SUBJECT: REVIEW OF PRELIMINARY ACCIDENT SEQUENCE PRECURSOR ANALYSIS  
OF CONDITION AT MCGUIRE NUCLEAR STATION, UNIT 2

**LER No. 370/96-002**

Event Description: 2B emergency diesel generator inoperable due to slow instrumentation response

**Licensee Comments**

Fig. 1. Dominant core damage sequence for LER No. 370/96-002.

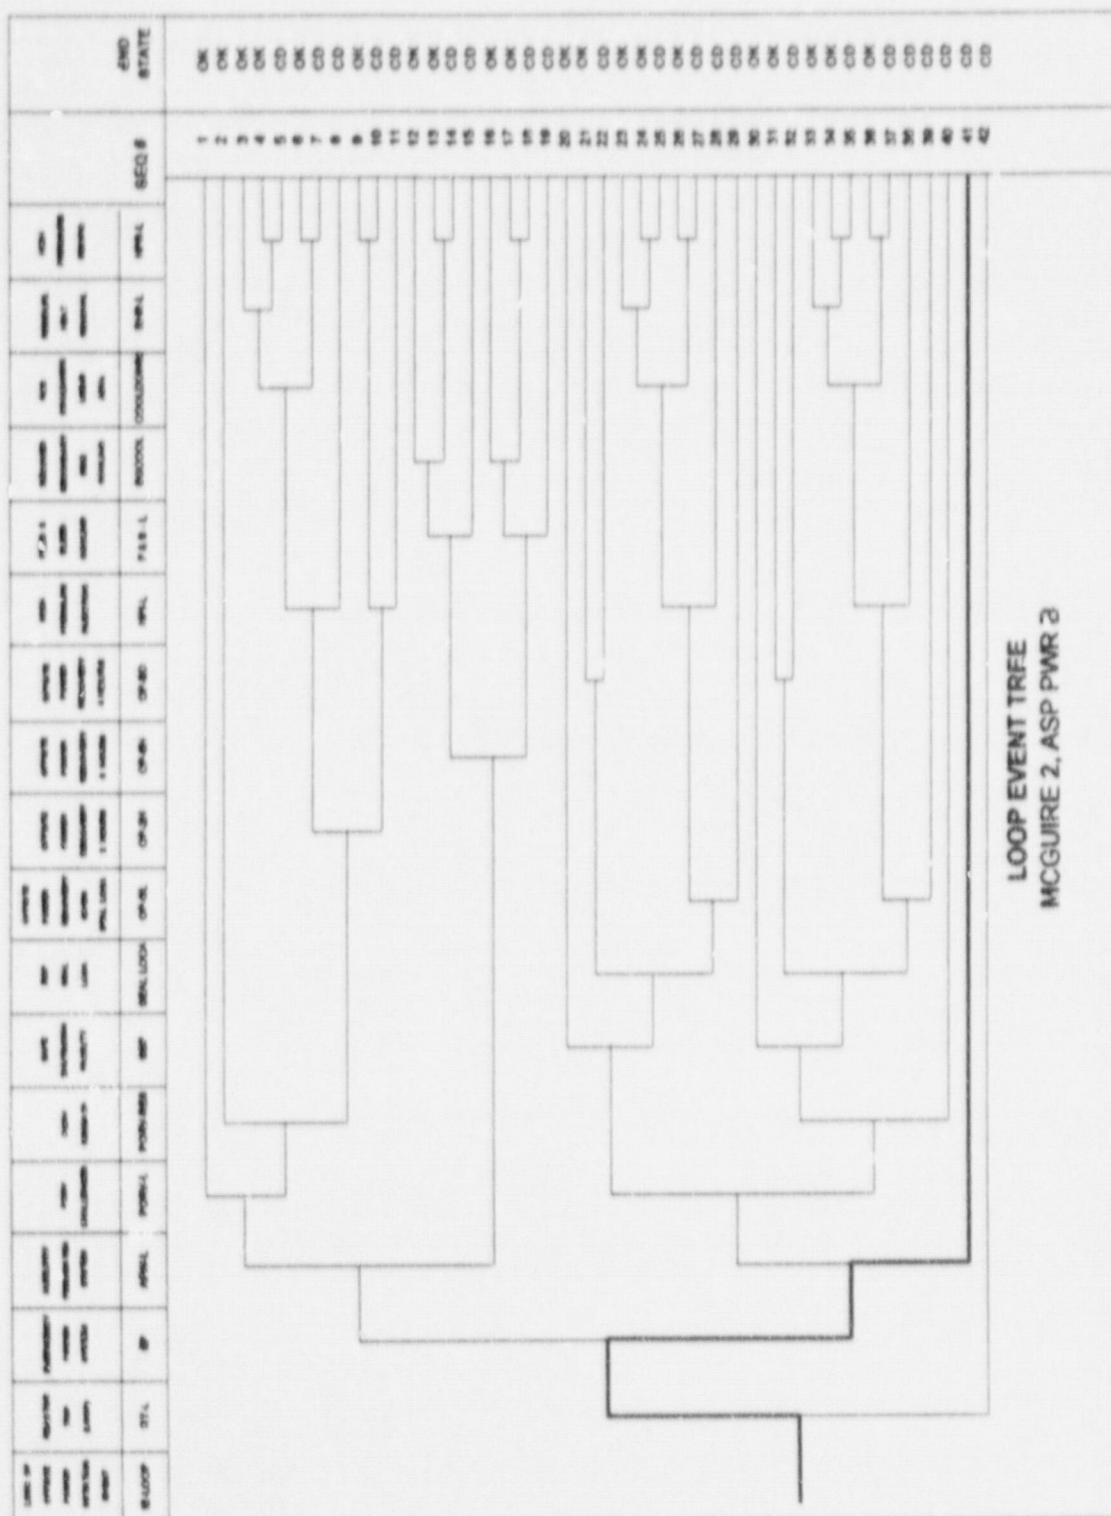
**Comment 4:** As required by the design basis, the SSF is required to be staffed and operational within 10 minutes. Plant personnel have verified that the SSF can be staffed and operational within 10 minutes. The assumption of 30 minutes (page 3 of the analysis) is too long and should be modified to indicate a time less than 10 minutes.

**Comment 5:** The probability of SSF failure assumed in the McGuire preliminary analysis is 0.36. The failure value was taken from the McGuire IPE report. This number includes both hardware failures (SSF DG fails to start or run) and operator errors (operators fail to start the SSF in time). Provided below are the top events from the SSF IPE model:

**Comment 7:** Sequences involving OEP-XHE-NOREC-BD result in core damage after battery failure. We assume that this leads to a loss of secondary side heat removal in the preliminary analysis. However, the turbine-driven emergency feedwater pump at McGuire can continue to operate without battery power since all valves remain in their open position. Furthermore, the SSF can provide control power to the turbine-driven emergency feedwater pump and steam generator level indication. In addition, the McGuire DC system is shared and the battery chargers can be supplied by either unit. Therefore, failure to recover power before battery failure would not necessarily lead to core damage at McGuire. LOOP sequences 21 and 30 [revised analysis sequences 22 and 32] appear to be a failure of secondary side heat removal after failure of the batteries. These sequences should be removed or modified to account for McGuire capabilities.

**Comment 8:** LOOP sequence 38 [revised analysis sequence 40] contains a failure of emergency power and failure of a PORV to re-close after opening. However, this sequence does not contain any events that would challenge the PORV such as failure of secondary side heat removal. For a blackout at McGuire, the PORVs are not expected to be challenged unless secondary side heat removal fails. These sequences should not be included in the analysis or additional failures should be included in the cut set.

**Response 4:** In the revised analysis, the SSF is included as a top event on the revised LOOP event tree (Fig. 1 in the analysis). The associated SSF fault tree now includes an *Operator Fails to Start SSF EDG Within 10 Minutes* basic event (SSF-XHE-XM-DGN). The probability for this basic event (0.1) is taken from the McGuire IPE.

**Response 5:** The SSF is now specifically included as a top event on the revised LOOP event tree (Fig. 1 in the analysis). Both short-term and long-term failures are typically considered in event modeling; therefore, SSF EDG failure to run and maintenance components were included. Operator errors involving the SSF are not included elsewhere in the revised model. The values presented in the above table were used as the basis for the inputs for the SSF fault tree, resulting in a nominal overall SSF failure probability of approximately 0.36.

**Response 7:** The SSF was included as a top event on the revised LOOP event tree (Fig. 1 in the analysis). Loss of control power to the turbine-driven emergency feedwater pump and steam generator level indication is not considered possible unless emergency power, the SSF, and battery power have all failed. Sequences 22 and 32 both involve a loss of emergency power and a failure of the SSF as shown in Table 3 in the revised analysis. Sharing battery chargers between units is not addressed in the McGuire IPE and no procedure was provided; therefore this possibility was not considered.

A study of the safety analyses performed at several plants has suggested that there is a possibility of a PORV lifting at most plants. Based on this review, a probability (0.37) is assigned to the potential for the PORVs being challenged (basic event PPR-SRV-CO-SBO), possibly leading to a failure of a PORV to re-close and a subsequent LOCA. This is the premise of LOOP sequence 40 shown in Figure 1 of the analysis.
